PLANNING COMMISSION MEETING

LOCATION: TOWNSHIP ANNEX, 7527 HIGHLAND ROAD, WHITE LAKE, MI 48383
THURSDAY, APRIL 17, 2025 – 6:30 PM

RE: White Lake Motors - Preliminary Site Plan Review, Final Site Plan and Final Engineering Review- 3rd Review

Combined Preliminary – Final Site Plan / Special Land Use Review for White Lake Charter Township, Michigan

SHEET
C-3

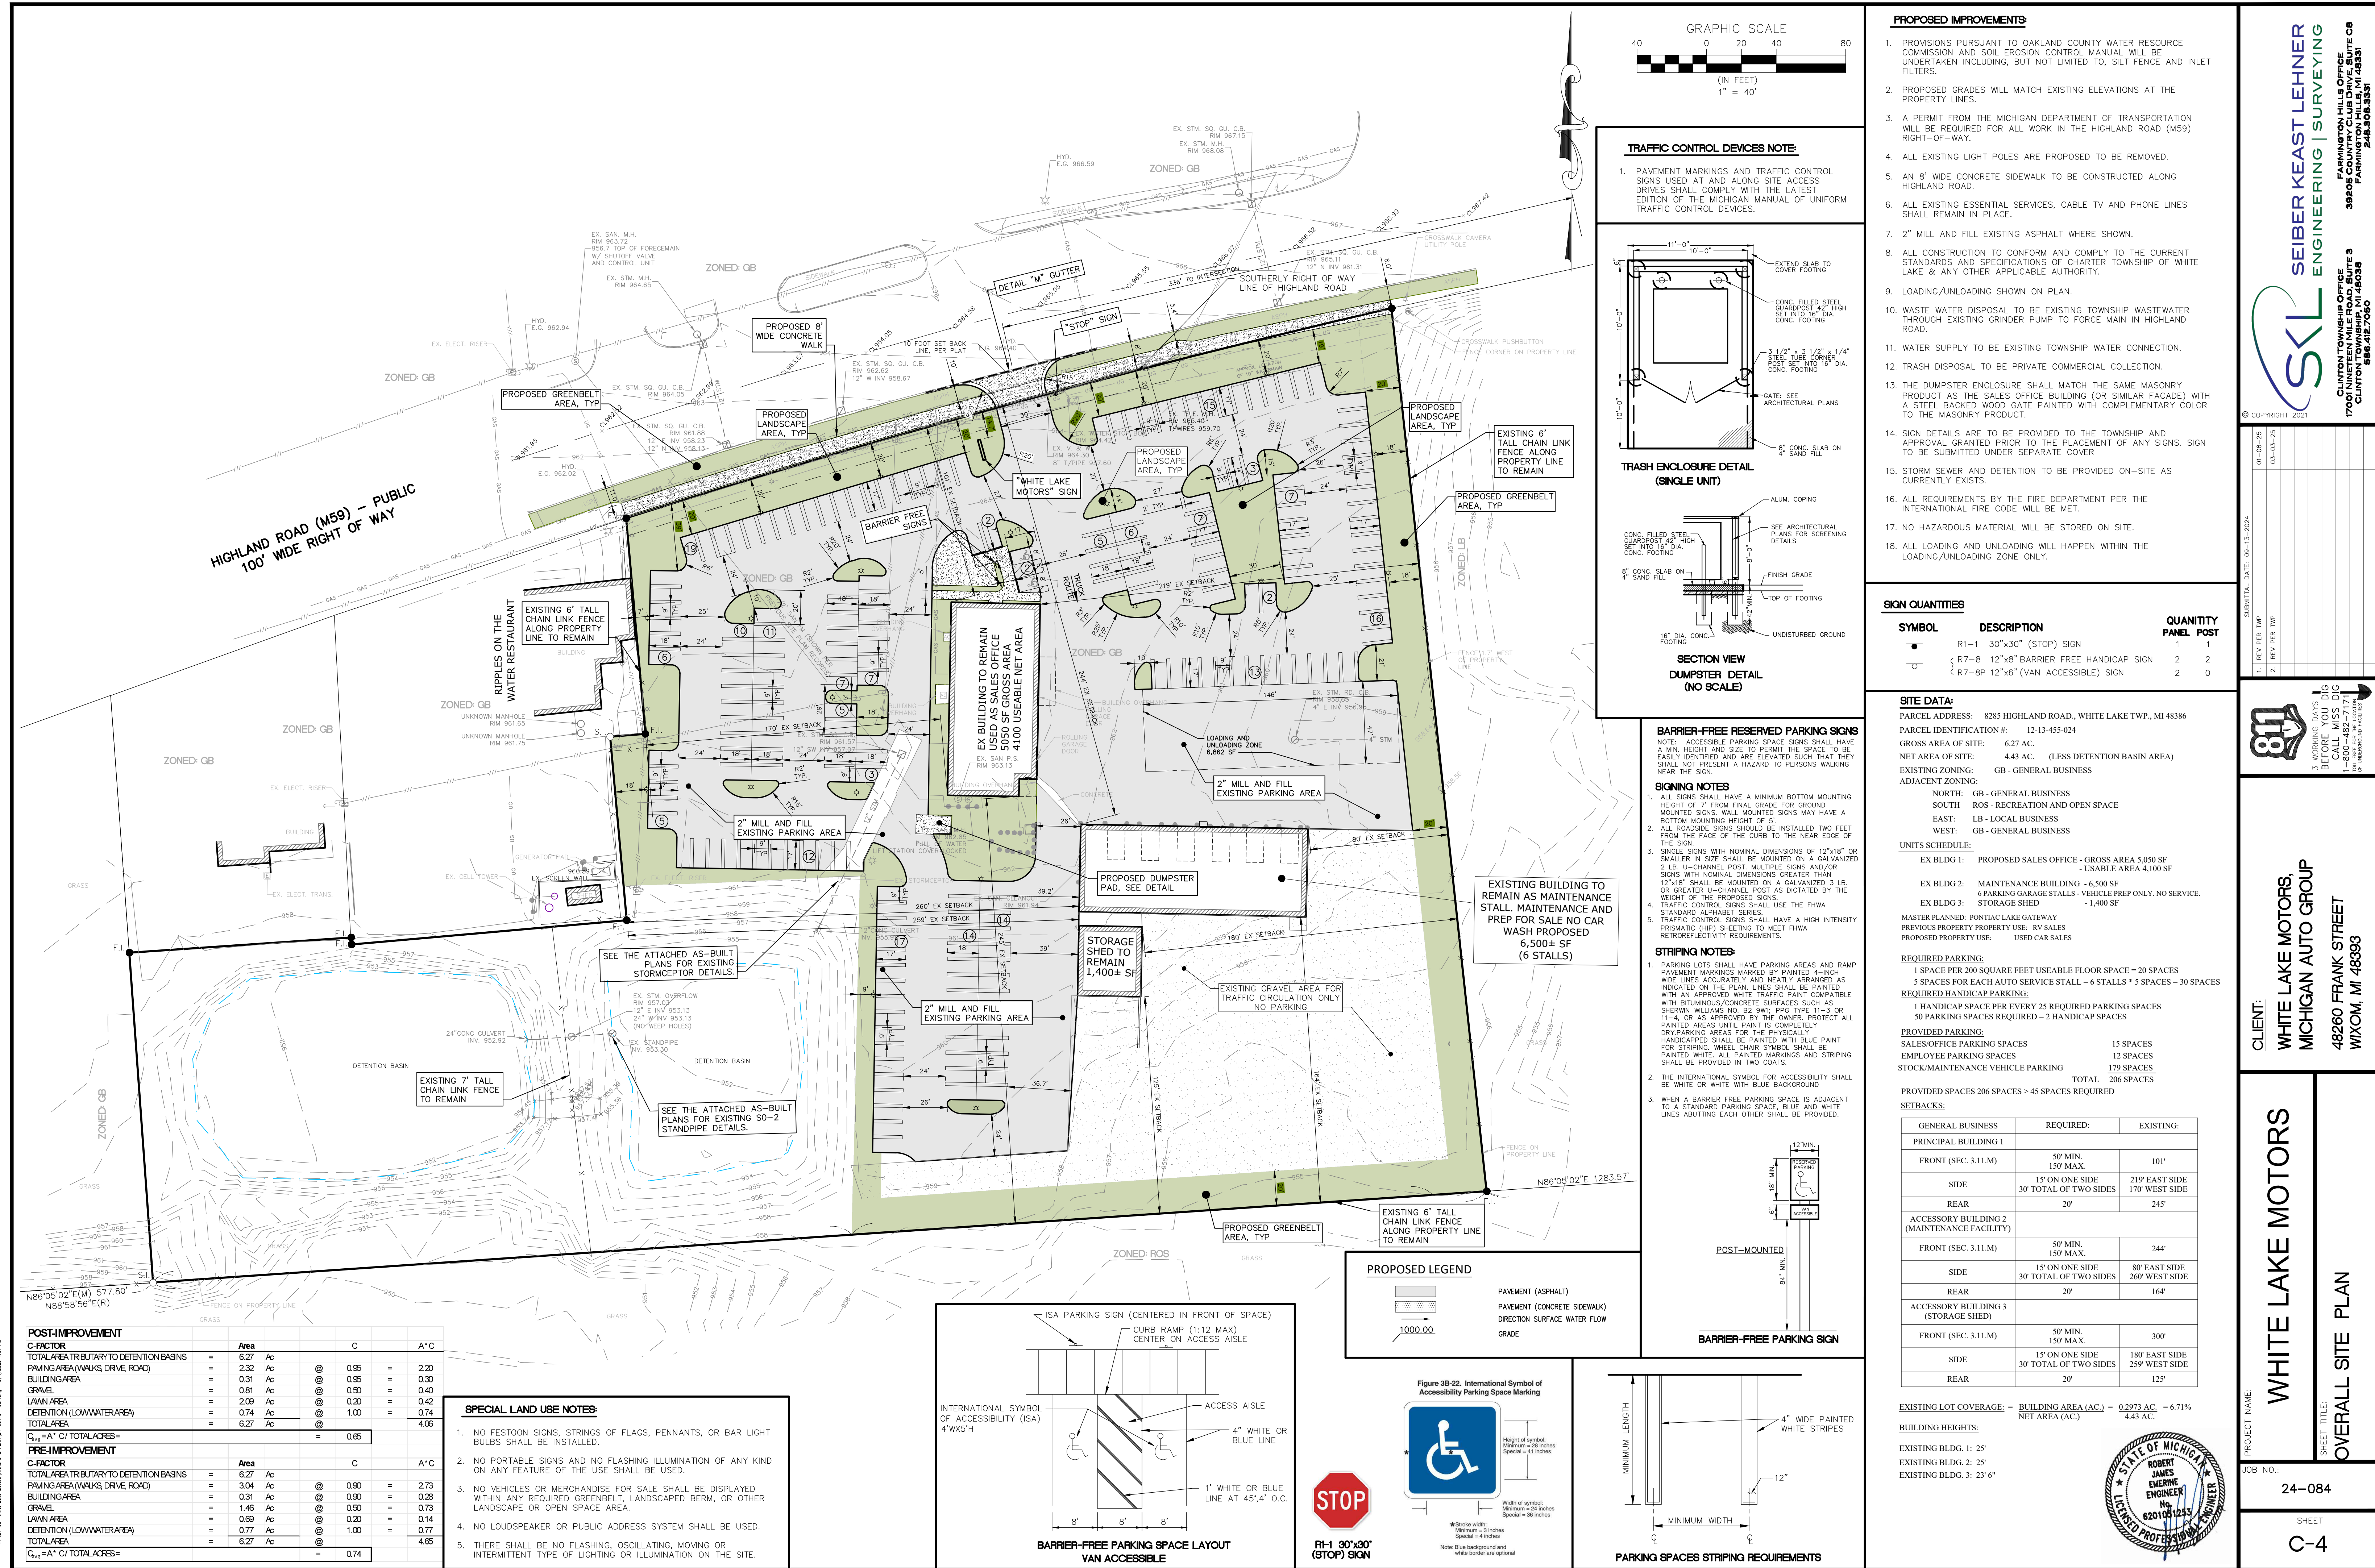
The demolition plan on Sheet C-3 indicates that the site will retain the perimeter fences, concrete storm drain, utility poles and the gravel surface in the southeast corner of the site. Sheet C-4 states the gravel area will be used for traffic circulation only. No parking will be permitted in this area. The majority of the site's asphalt and concrete infrastructure will be demolished and redone under a new layout better suited to meet operational needs and zoning standards.

Fence standards are outlined in Section 5.12. Sheet C-3 indicates the perimeter fencing is to remain. A five (5) foot tall black iron fence is proposed to remain along the Highland Road (M-59) frontage. Existing six (6) foot high chain link fence is along the east, south, and west perimeter. All fence heights and materials are compliant with current standards. We recommend the front property line fence be removed to improve aesthetics of the site and intent of the gateway area.

L-1

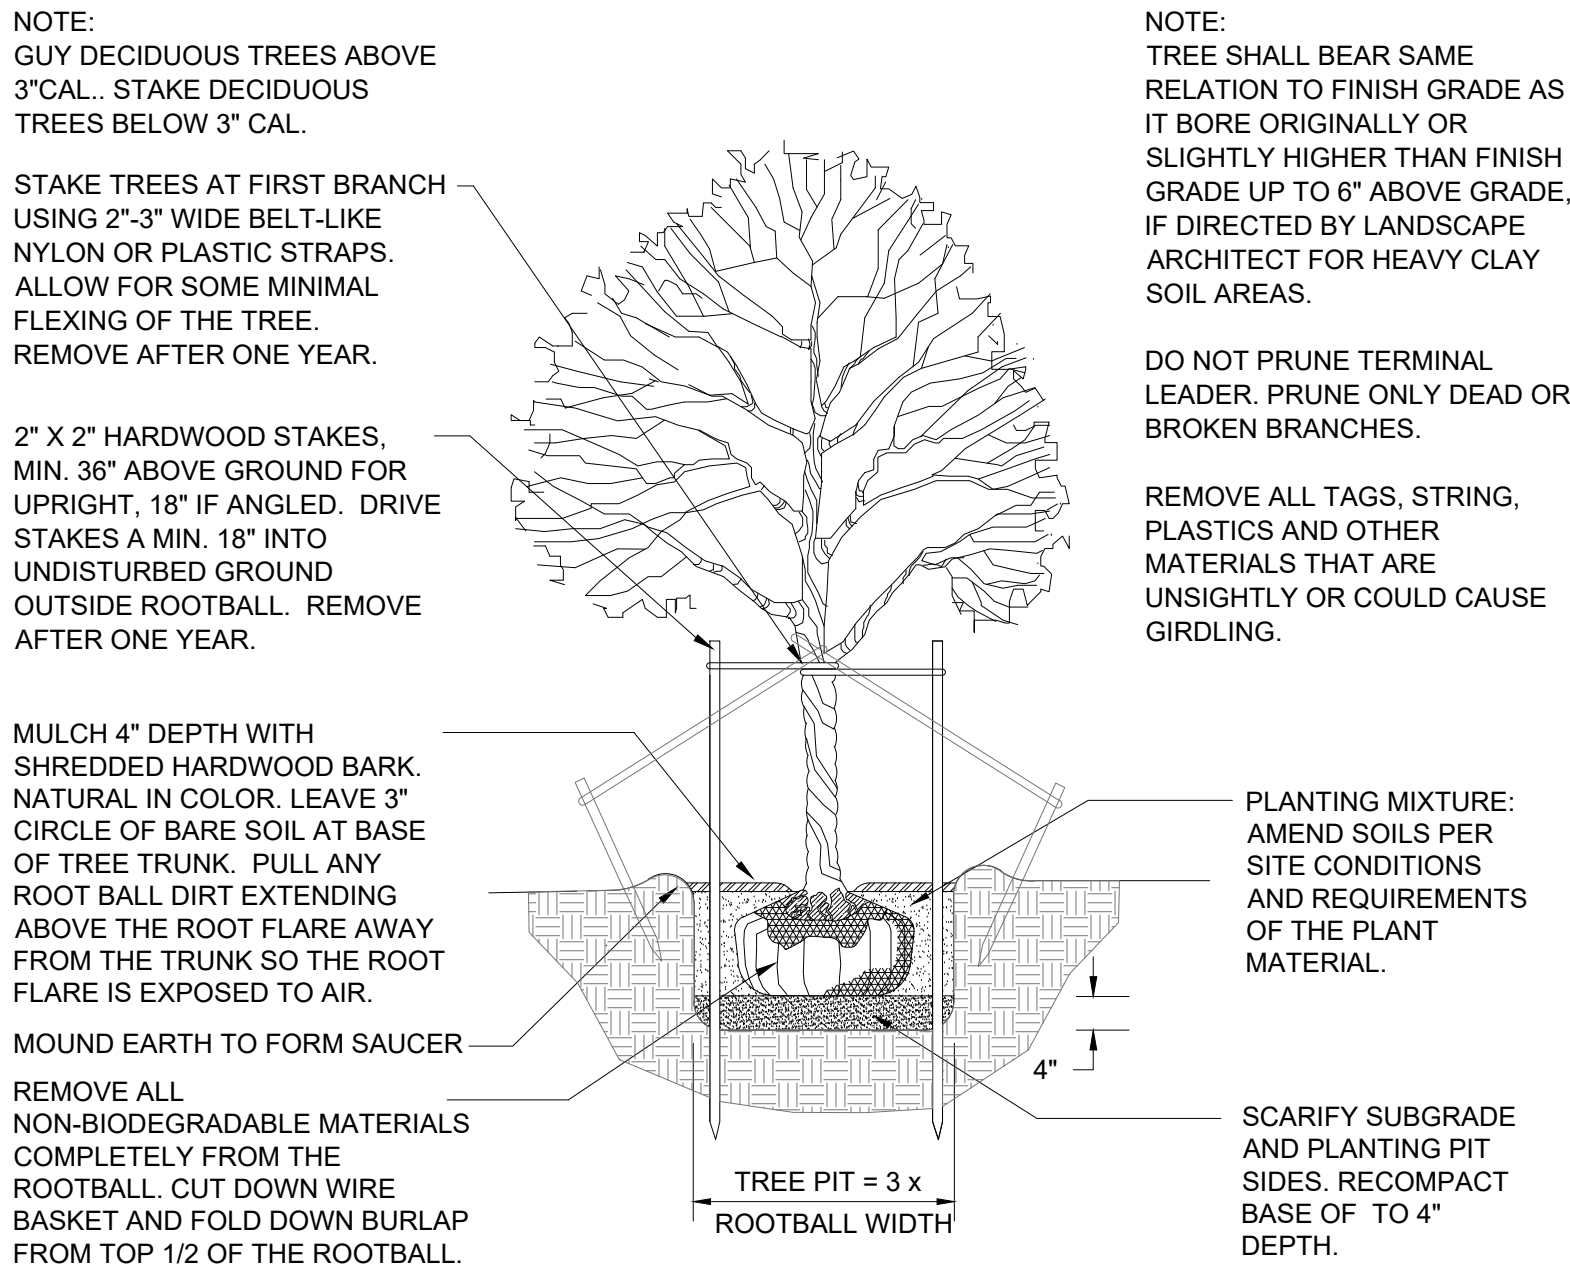
1. *Sheet L-1-North side of easternmost detention basin- The proposed tree types and location have changed since the previous submittal. The easternmost Concolor Fir is too close to the existing storm sewer and also appears to be shown over the location where the existing Stormceptor is. Please refer to the existing as built plans for General RV for the Stormceptor location and show this structure on the landscape plan as well as relocate this tree. **Comment partially addressed. Although the tree has been relocated away from the existing storm sewer, the location of the existing Stormceptor has not been shown on this plan sheet. Please show on this sheet.***

A note on Sheet L-1 indicates the large tree requirement along the Highland Road (M-59) greenbelt cannot be met due to existing utilities east of the access drive. While large evergreen and shade trees are not to be placed over underground or beneath overhead utilities, the applicant has provided the required count using ornamental trees that will not interfere with utilities. This will require a waiver from the Planning Commission.

Sheet L-1 provides interior landscaping calculations. The shrub counts are short of requirements. One hundred fifty four (554) shrubs will be required to meet standards or a waiver will be required.

PROJECT NUMBER:	763515
SCALE:	AS SHOWN
DRAWN BY:	PT
CHECKED BY:	MT/KC
DATE:	12.18.2024
ISSUE:	PERMIT
SHEET:	PICK DIRECTIONAL SIGNAGE PLAN
OGP-1

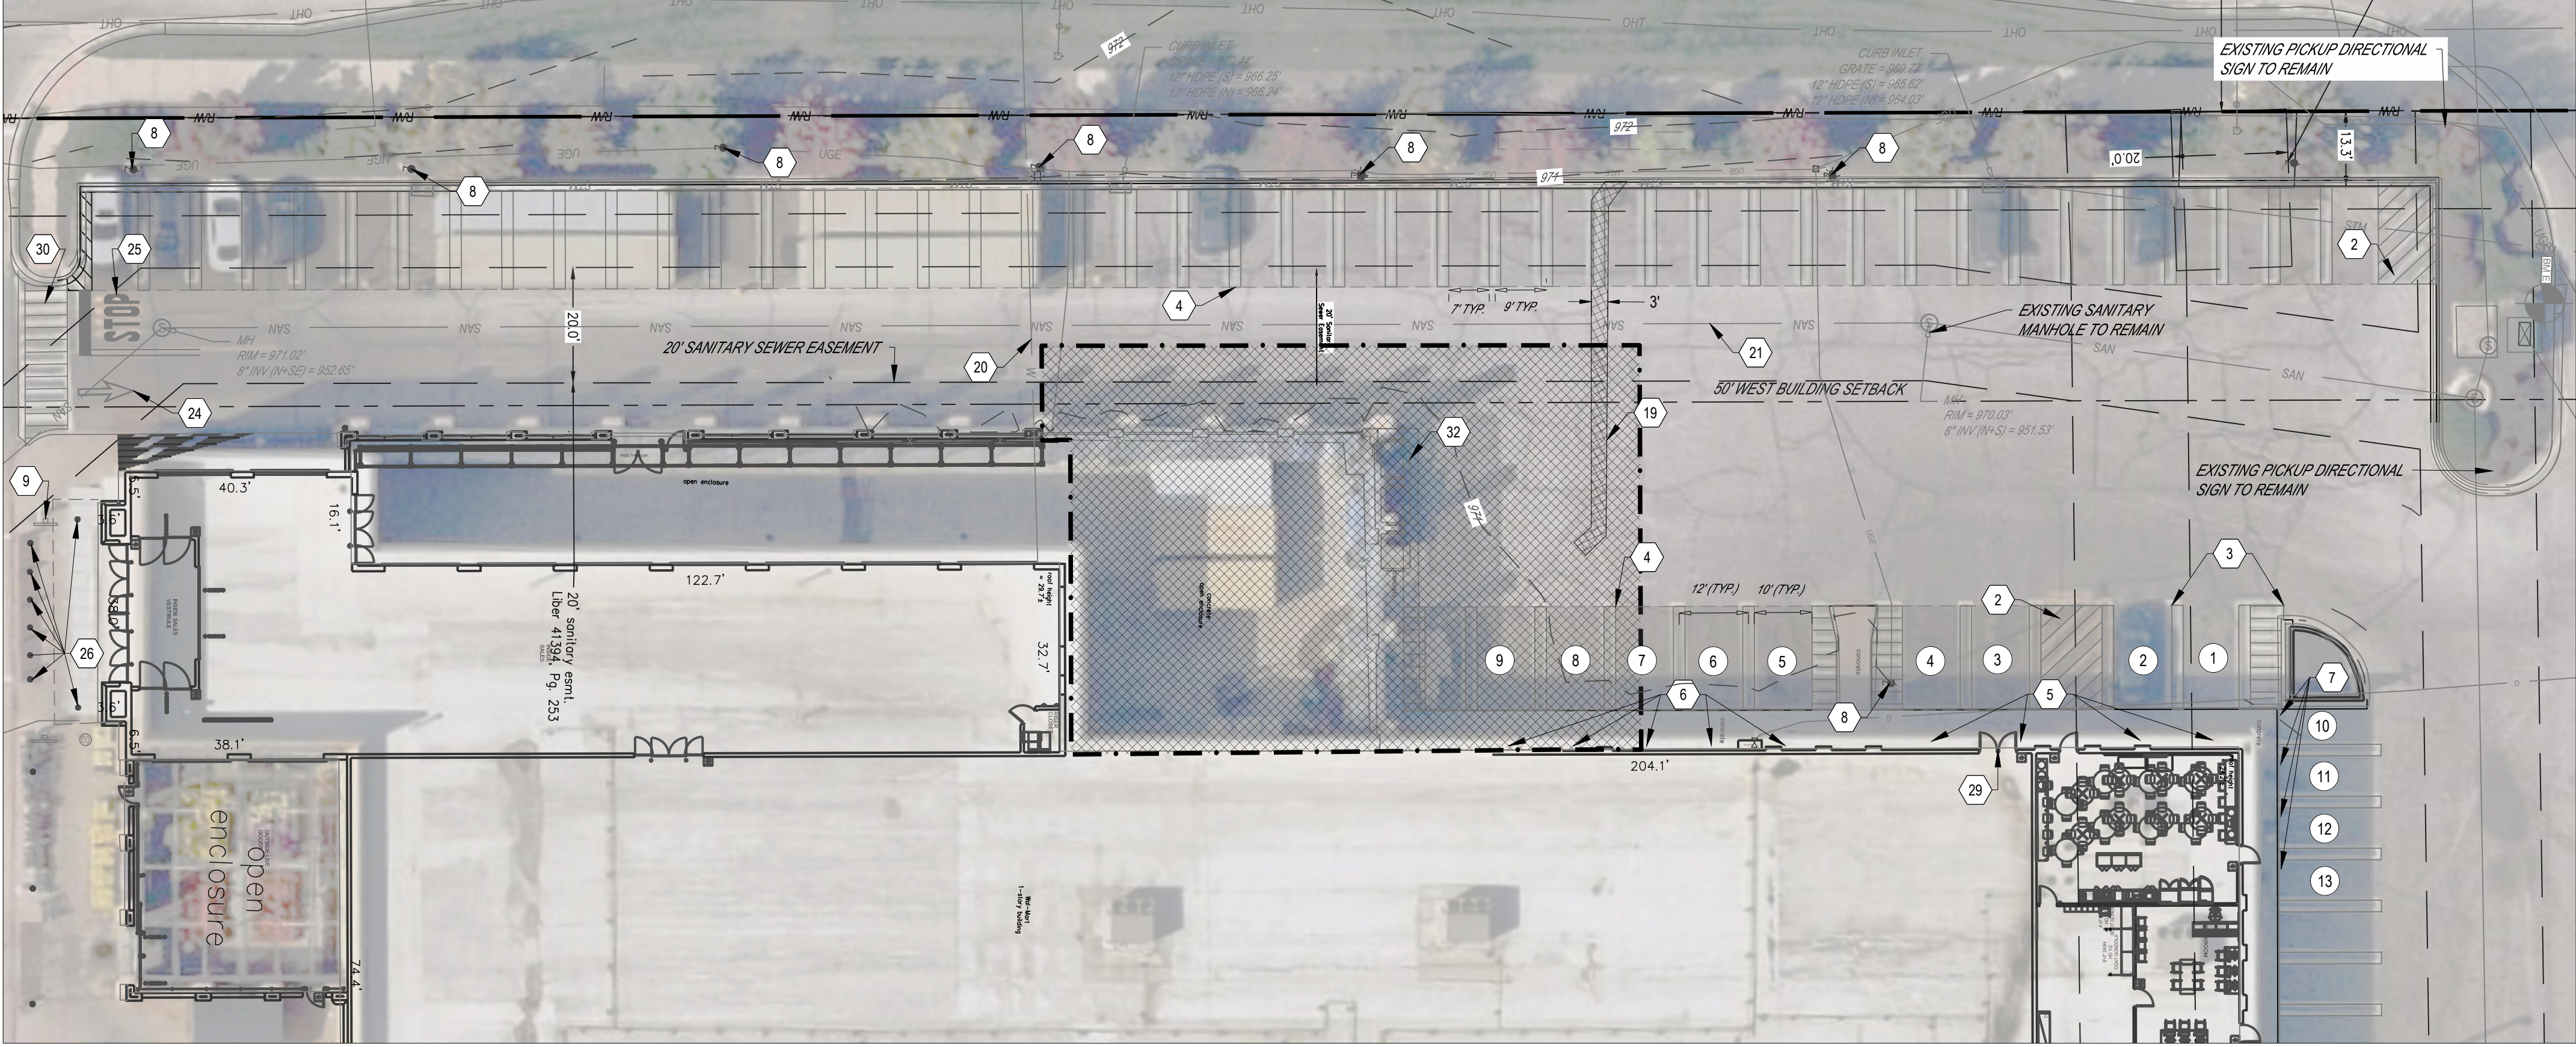
2. *Sheet OGP-1- Provide White Lake Township Engineering Design Standards notes Section A. 8. a-d on this sheet. **Comment addressed. Notes have now been added to this plan sheet.***

Sheet OGP-1 of the Applicant's proposed civil plans includes a table showing over 30 exterior pickup signs, the vast majority of which are post-pylon signs. Per Section 5.9.J.i.c. of the Township's Zoning ordinance, only one freestanding sign is permitted per lot or parcel. Therefore, these signs must be included and agreed to in the revised Planned Development Agreement. **Comment Outstanding.**
